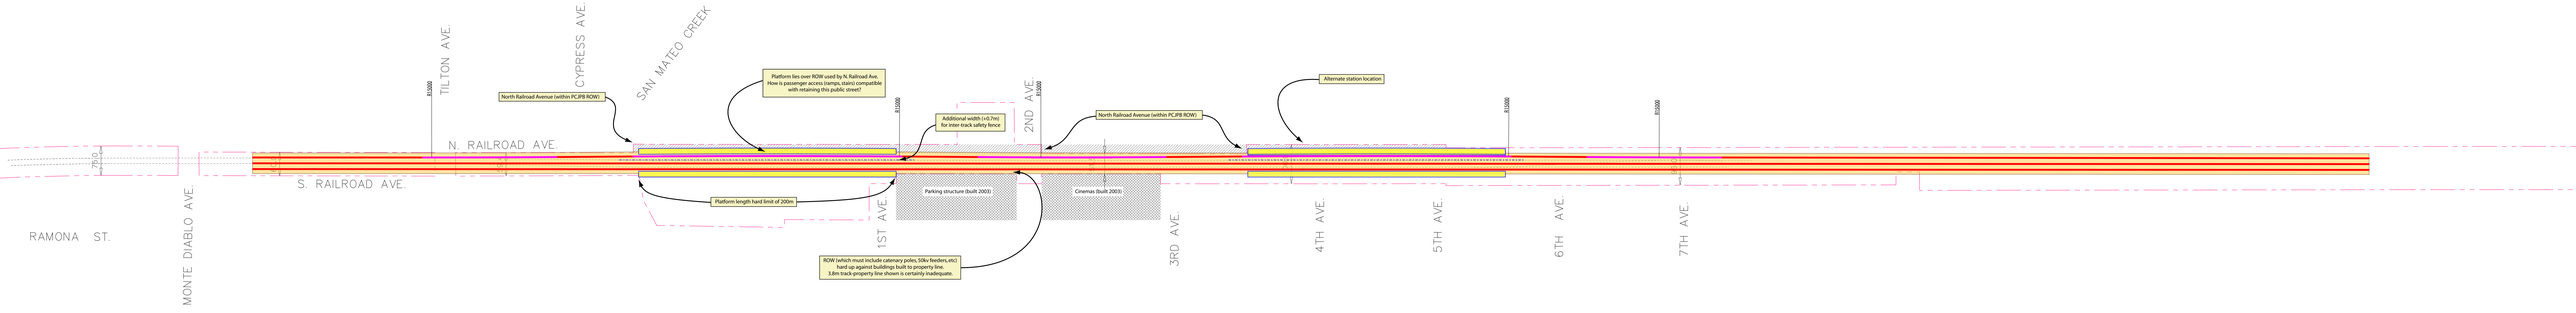
TILTON AVE.
CYPRESS AVE.
SAN MATEO CREEK
North Railroad Avenue (within PCJPB ROW)
Platform lies over ROW used by N. Railroad Ave. How is passenger access (ramps,stairs) compatible with retaining this public street?
Additional width (+0.7m) for inter track safety fence
2ND AVE.
North Railroad Avenue (within PCJPB ROW)
Alternate station location
N. RAILROAD AVE.
S. RAILROAD AVE.
Platform length hard limit of 200m
Parking structure (built 2003)
Cinemas (built 2003)
ROW (which must include catenary poles, 50kv feeders, etc) hard up against buildings built to property line. 3.8m track-property line shown is certainly inadequate.
RAMONA ST.
MONTE DIABLO AVE.
1ST AVE.
3RD AVE.
4TH AVE.
5TH AVE.
6TH AVE.
7TH AVE.
